SUBJECT TO SECTION 4.55 CHANGE

Schedule of Amendments:

691 Pittwater Road

Ground Floor Plan

Level 1 Floor Plan

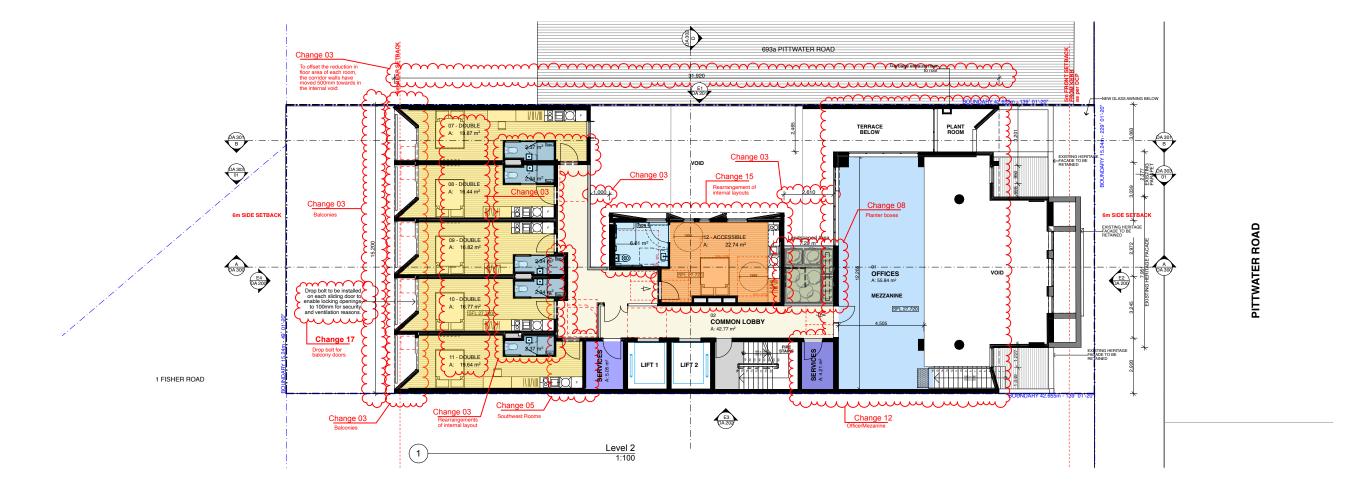
3 – Balconies:
Rooms at the front and rear of the boarding house have been reconfigured to accommodate balconies, to increase amenity for lodgers. The balconies do not encroach into required setbacks, with only the balustrade within the 300mm articulation zone. Access to the balconies is proposed via a glazed silding door, which also provides improved access to daylight and natural ventilation for these rooms. Frameless glass ballustrades are proposed to allow the strong vertical proportions of the façade to be maintained. To offset the reduction in floor area of each room, the corridor walls have moved 500mm towards the internal void. Corridor widths for accessibility have been maintained, as has 1m between the corridor be be considered unenclosed. This reconfiguration does not affect compliance with FSR controls.

5 — Southwest Rooms:
To increase long-term amenity for the Rooms adjacent the side boundary to the south-west, these Rooms have been reconfigured to utilise the void space that existed between the Rooms and the core. Pre-cast concrete panels are proposed to what was previously an opening, as the openings may only exist until the neighbouring site at 687 Pittwater Road is developed. To maintain the readability of 3 distinct forms on this faqade until the neighbouring site is developed, the additional pre-cast concrete is proposed to be a darker colour with textured relief to contrast and recede from the main pre-cast façade. This reconfiguration does not affect compliance with FSR controls.

To address concerns with waterproofing, the masonry planter boxes are proposed to be replaced with pots. The rearrangement of landscaped areas within the Urban Farm has allowed the loss of landscaping associated with inclusion of the shared laundries and reconfiguration of the Southwest Rooms to be offset, for no net loss of landscaping overall.

12 – Office/Mezzanine:
The width of the office space and mezzanine increased, Services room to corridor adjacent to office space

15 – Rearrangement of Internal Layouts: The internal layout has been rearranged to simplify and improve the the amenity.

Drop bolt to all balcony doors for security/ventilation.

Level 4 Floor Plan

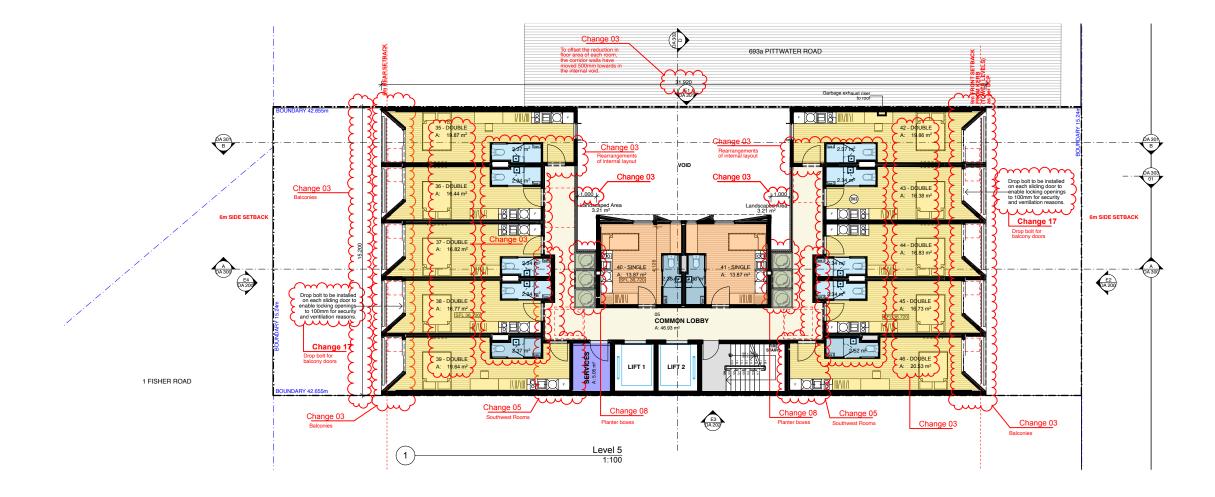
3 – Balconies:
Rooms at the front and rear of the boarding house have been reconfigured to accommodate balconies, to increase amenity for lodgers. The balconies do not encroach into required setbacks, with only the balustrade within the 300mm articulation zone. Access to the balconies is proposed via a glazed sliding door, which also provides improved access to daylight and natural ventilation for these rooms. Frameless glass balustrades are proposed to allow the strong vertical proportions of the façade to be maintained. To offset the reduction in floor area of each room, the corridor bal have moved 500mm towards the internal void. Corridor widths for accessibility have been maintained, as has 1m between the corridor balustrades and central core required for the corridor to be considered unenclosed. This reconfiguration does not affect compliance with FSR controls.

5 — Southwest Rooms:
To increase long-term amenity for the Rooms adjacent the side boundary to the south-west, these Rooms have been reconfigured to utilise the void space that existed between the Rooms and the core. Pre-cast concrete panels are proposed to what was previously an opening, as the openings may only exist until the neighbouring site at 687 Pittwater Road is developed. To maintain the readability of 3 distinct forms on this faqade until the neighbouring site is developed, the additional pre-cast concrete is proposed to be a darker colour with textured relief to contrast and recede from the main pre-cast façade. This reconfiguration does not affect compliance with FSR controls.

To address concerns with waterproofing, the masonry planter boxes are proposed to be replaced with pots. The rearrangement of landscaped areas within the Urban Farm has allowed the loss of landscaping associated with inclusion of the shared laundries and reconfiguration of the Southwest Rooms to be offset, for no net loss of landscaping overall.

Drop bolt to all balcony doors for security/ventilation.
Typical

Level 6 Floor Plan

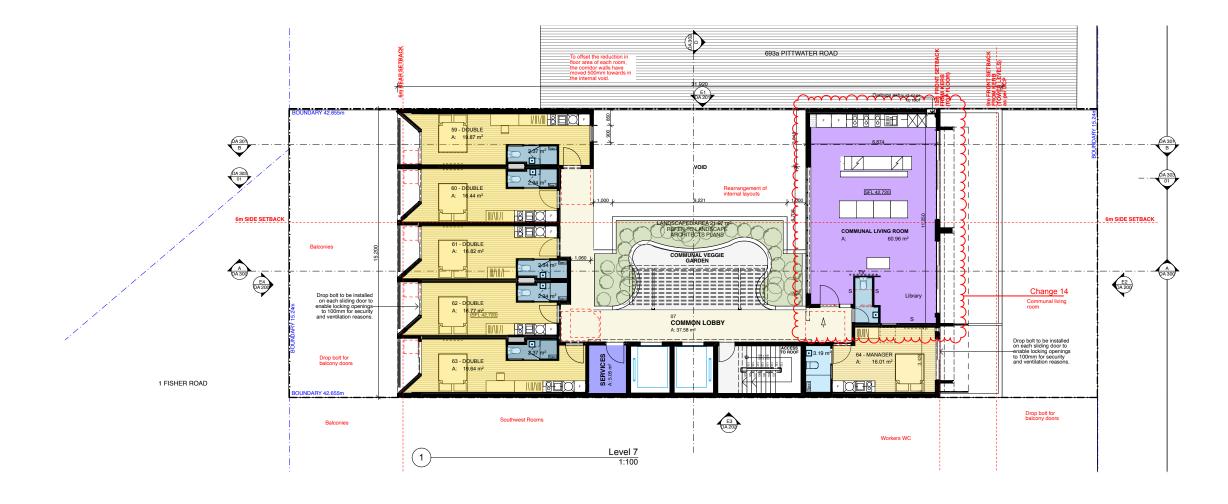
3 – Balconies:
Rooms at the front and rear of the boarding house have been reconfigured to accommodate balconies, to increase amenity for lodgers. The balconies do not encroach into required setbacks, with only the balustrade within the 300mm articulation zone. Access to the balconies is proposed via a glazed sliding door, which also provides improved access to daylight and natural ventilation for these rooms. Frameless glass balustrades are proposed to allow the strong vertical proportions of the façade to be maintained. To offset the reduction in floor area of each room, the corridor bal have moved 500mm towards the internal void. Corridor widths for accessibility have been maintained, as has 1m between the corridor balustrades and central core required for the corridor to be considered unenclosed. This reconfiguration does not affect compliance with FSR controls.

5 — Southwest Rooms:
To increase long-term amenity for the Rooms adjacent the side boundary to the south-west, these Rooms have been reconfigured to utilise the void space that existed between the Rooms and the core. Pre-cast concrete panels are proposed to what was previously an opening, as the openings may only exist until the neighbouring site at 687 Pittwater Road is developed. To maintain the readability of 3 distinct forms on this façade until the neighbouring site is developed, the additional pre-cast concrete is proposed to be a darker colour with textured relief to contrast and recede from the main pre-cast façade. This reconfiguration does not affect compliance with FSR controls.

7 – Workers WC:
Level 7 Floor Plan has been reconfigured to include
a worker's WC in proximity to the plant areas. This
eliminates the need for workers to descend to
Ground Floor or Level 1 to use the facilities. The
kitchen within the communal room has been
relocated to the North-eastern end to accommodate
this change.

Drop bolt to all balcony doors for security/ventilation. Typical

Level 7 Floor Plan

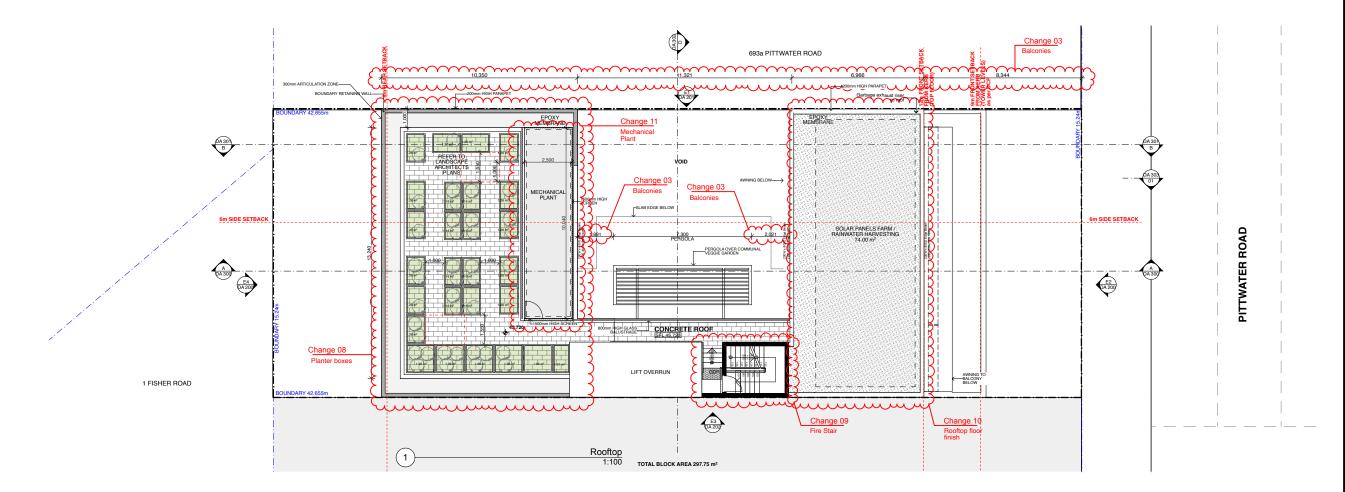
3 – Balconies:
Rooms at the front and rear of the boarding house have been reconfigured to accommodate balconies, to increase amenity for lodgers. The balconies do not encroach into required setbacks, with only the balustrade within the 300mm articulation zone. Access to the balconies is proposed via a glazed sliding door, which also provides improved access to daylight and natural ventilation for these rooms. Frameless glass balustrades are proposed to allow the strong vertical proportions of the façade to be maintained. To offset the reduction in floor area of each room, the corridor balave moved 500mm towards the internal void. Corridor widths for accessibility have been maintained, as has 1m between the corridor balustrades and central core required for the corridor to be considered unenclosed. This reconfiguration does not affect compliance with FSR controls.

To address concerns with waterproofing, the masonry planter boxes are proposed to be replaced with pots. The rearrangement of landscaped areas within the Urban Farm has allowed the loss of landscaping associated with inclusion of the shared laundries and reconfiguration of the Southwest Rooms to be offset, for no net loss of landscaping overall

9 – Fire Stair:
To address NCC non-compliances with the Fire Stair being unenclosed at the Root Level, the Fire Stair has been reconfigured at Roof level only to allow a concrete lid to be constructed to enclose the stair. The lid does not encroach the allowable height limit. No other changes are proposed to the Fire Stair.

10 – Rooftop floor finish:
The pebble finish on the Roof level service areas is to be replaced with a trafficable epoxy membrane to allow a more durable and serviceable finish.

11 — Mechanical Plant:
The Urban Farm on Roof level has been shifted towards the rear of the building to create a dedicated area for locating mechanical plant. To ensure acoustic and visual amenity for residents, the mechanical plant area is proposed to be surrounded by an acoustic barrier in a powdercoat finish. The barrier is proposed to be 1500mm high, which does not encroach the allowable height limit. The barrier will also act a balustrade, providing safe access for maintenance.

Rooftop Floor Plan

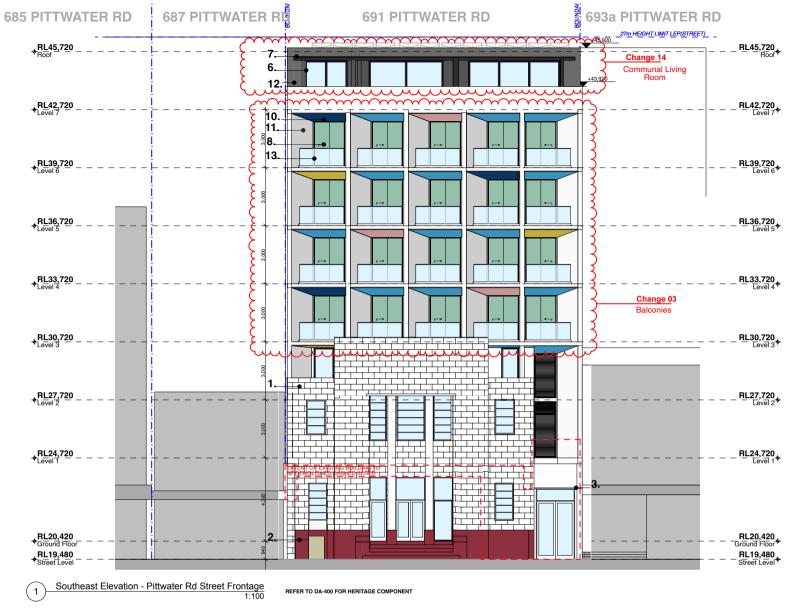
3 – Balconies:
Rooms at the front and rear of the boarding house have been reconfigured to accommodate balconies, to increase amenity for lodgers. The balconies do not encroach into required setbacks, with only the balustrade within the 300mm articulation zone. Access to the balconies is proposed via a glazaed sliding door, which also provides improved access to daylight and natural ventilation for these rooms. Frameless glass balustrades are proposed to allow the strong vertical proportions of the façade to be maintained. Offset the reduction in floor areas of each room, the corridor walls have moved 500mm towards the internal void. Corridor widths for accessibility have been maintained, as has 1m between the corridor ballow that strades and central core required for the corridor to be considered unenclosed. This reconfiguration does not affect compliance with FSR controls.

14 – Communal Living Room:
Kitchen relocated to the north-eastern wall, Increased glazing to the communal living room. Width and area of the communal living room has

Elevations 2

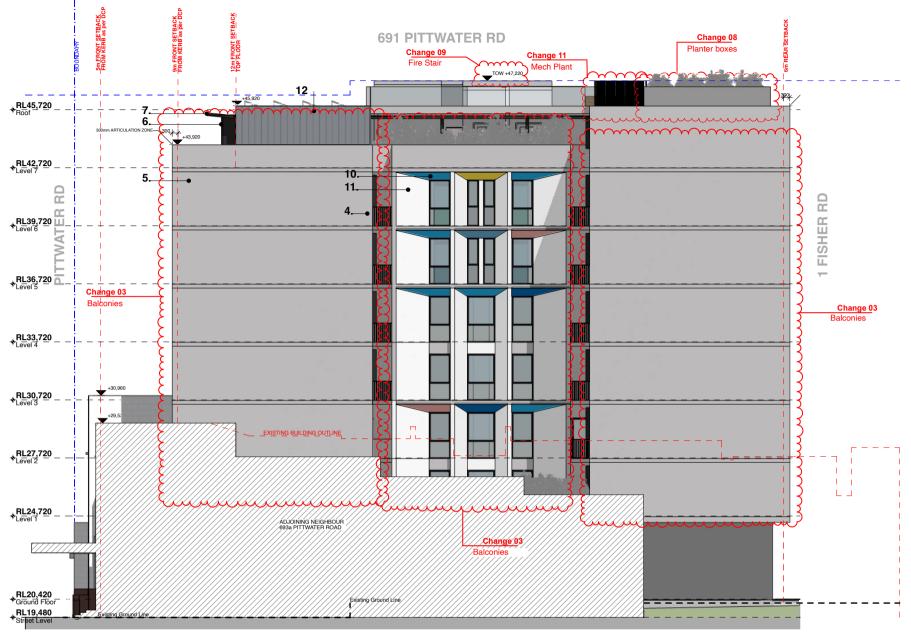
Rooms at the front and rear of the boarding house have been reconfigured to accommodate balconies, to increase amenity for lodgers. The balconies do not encroach into required setbacks, with only the balustrade within the 300mm articulation zone. Access to the balconies is proposed via a glazed sliding door, which also provides improved access to daylight and natural ventilation for these rooms. Frameless glass balustrades are proposed to allow the strong vertical proportions of the facade to be maintained. To offset the reduction infor area of each room, the corridor walls have moved 500mm towards the internal void. Corridor widths for accessibility have been maintained, as has 1m between the corridor balustrades and central core required for the corridor to be considered unenclosed. This reconfiguration does not affect compliance with FSR controls.

8 – Planter boxes:
To address concerns with waterproofing, the masonry planter boxes are proposed to be replaced with pots. The rearrangement of landscaped areas within the Urban Farm has allowed the loss of landscaping associated with inclusion of the shared laundries and reconfiguration of the Southwest Rooms to be offset, for no net loss of landscaping overall.

Elevations 3

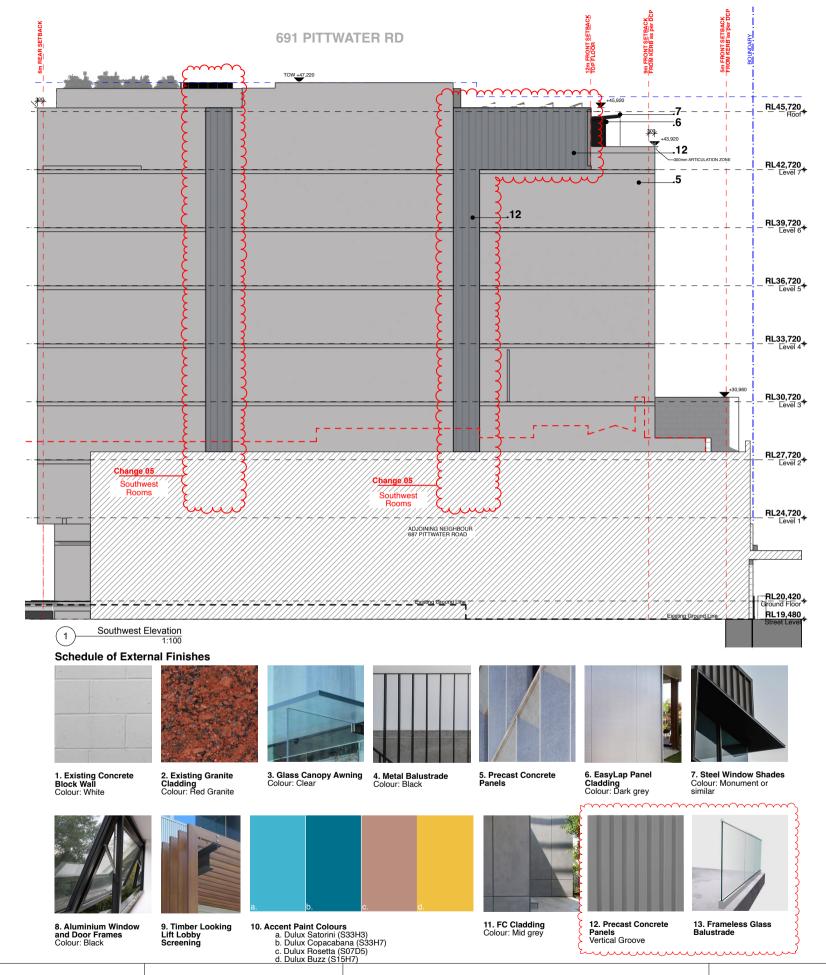
3 – Balconies:
Rooms at the front and rear of the boarding house have been reconfigured to accommodate balconies, to increase amenity for lodgers. The balconies do not encroach into required setbacks, with only the balustrade within the 300mm articulation zone. Access to the balconies is proposed via glazed sliding door, which also provides improved access to daylight and natural ventilation for these rooms. Frameless glass balustrades are proposed to allow the strong vertical proportions of the façade to be maintained. To offset the reduction in floor area of each room, the corridor walls have moved 500mm towards the internal void. Corridor widths for accessibility have been maintained, as has 1 mb between the corridor balustrades and central core required for the corridor to be considered unenclosed. This reconfiguration does not affect compliance with FSR controls.

To address concerns with waterproofing, the masonry planter boxes are proposed to be replaced with pots. The rearrangement of landscaped areas within the Urban Farm has allowed the loss of landscaping associated with inclusion of the shared laundries and reconfiguration of the Southwes Rooms to be offset, for no net loss of landscaping overall.

9 – Fire Stair:
To address NCC non-compliances with the Fire Stair being unenclosed at the Roof Level, the Fire Stair has been reconfigured at Roof level only to allow a concrete lid to be constructed to enclose the stair. The lid does not encroach the allowable height limit. No other changes are proposed to the Fire Stair.

The Urban Farm on Roof level has been shifted towards the rear of the building to create a dedicated area for locating mechanical plant. To ensure acoustic and visual amenity for residents, the mechanical plant area is proposed to be surrounded by an acoustic barrier in a powdercoat finish. The barrier is proposed to be 1500mm high, which does not encroach the allowable height limit. The barrier will also act a balustrade, providing safe access for maintenance.

Drawing Sections 01

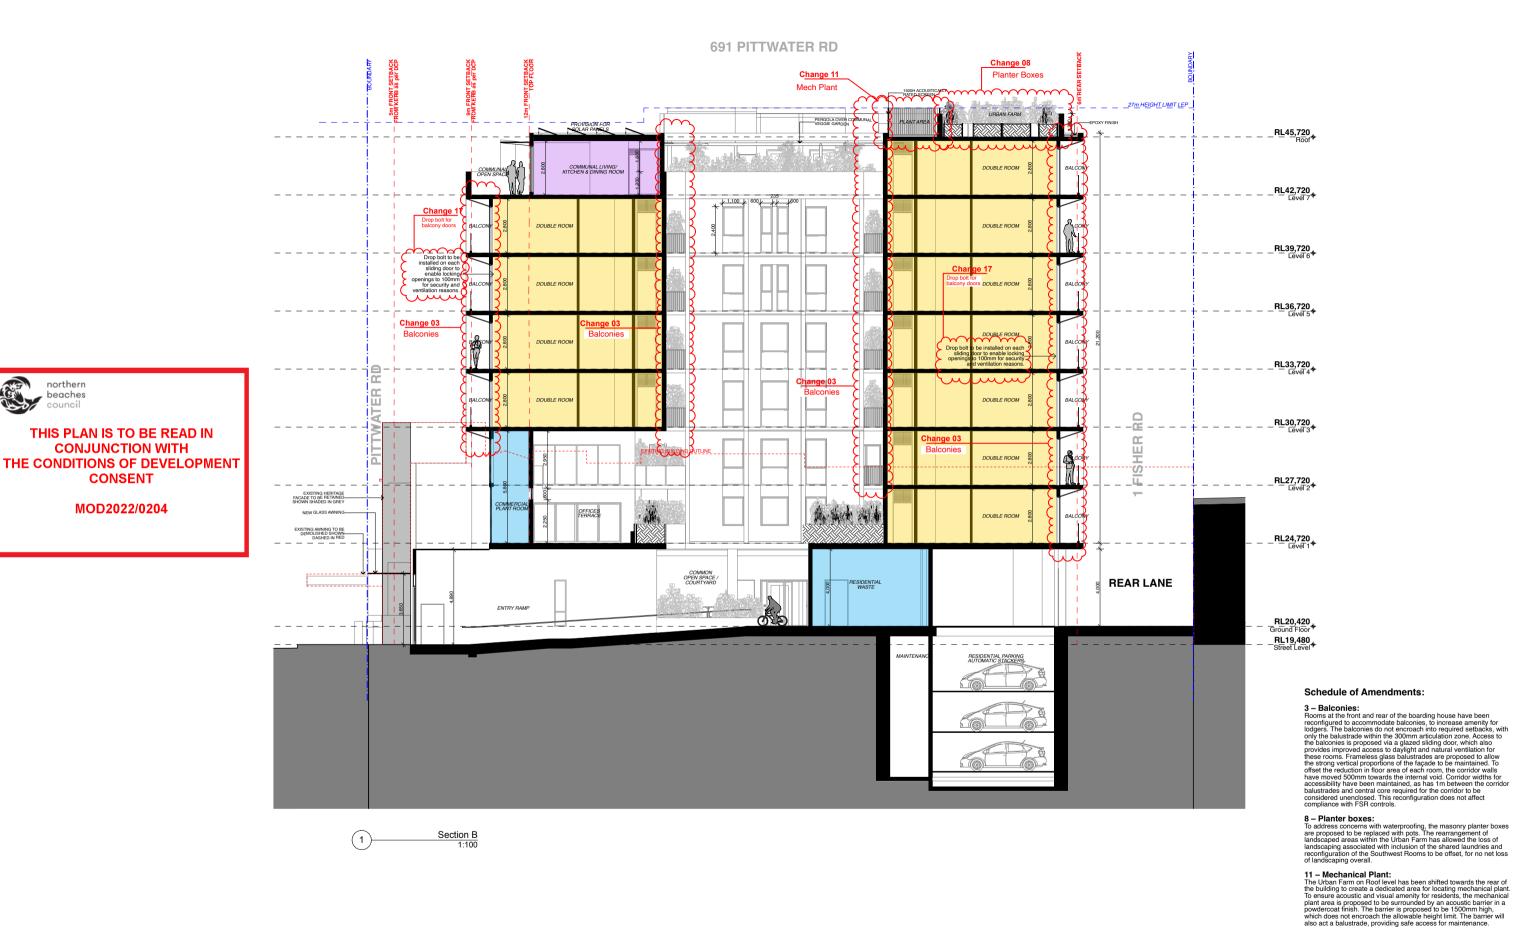
3 – Balconies:
Rooms at the front and rear of the boarding house have been reconfigured to accommodate balconies, to increase amenity for lodgers. The balconies do not encroach into required setbacks, with only the balustrade within the 300mm articulation zone. Access to the balconies is proposed via a glazed sliding door, which also provides improved access to daylight and natural ventilation for these rooms. Frameless glass balustrades are proposed to allow the strong vertical proportions of the façade to be maintained. To offset the reduction in floor area of each room, the corridor walls have moved 500mm towards the internal void. Corridor widths for accessibility have been maintained, as has 1m between the corridor balustrades and central core required for the corridor to be considered unenclosed. This reconfiguration does not affect compliance with FSR controls.

New shared laundries are proposed on Levels 3 & 4. Level 3 laundry will provide 5 washing machines and 5 clothes dryers in a stacked arrangement as well as a tub, whereas Level 4 laundry will provide 4 washing machines, 6 clothes dryers and a tub. One clothes dryer will be located at low level for accessibility.

To address concerns with waterproofing, the masonry planter boxes are proposed to be replaced with pots. The rearrangement of landscaped areas within the Urban Farm has allowed the loss of landscaping associated with inclusion of the shared laundries and reconfiguration of the Southwest Rooms to be offset, for no net loss of landscaping overall.

11 – Mechanical Plant:
The Urban Farm on Roof level has been shifted towards the rear of the building to create a dedicated area for locating mechanical plant. To ensure acoustic and visual amenity for residents, the mechanical plant area is proposed to be surrounded by an acoustic barrier in a powdercoat finish. The barrier is proposed to be 1500mm high, which does not encroach the allowable height limit. The barrier will also act a balustrade, providing safe access for maintenance.
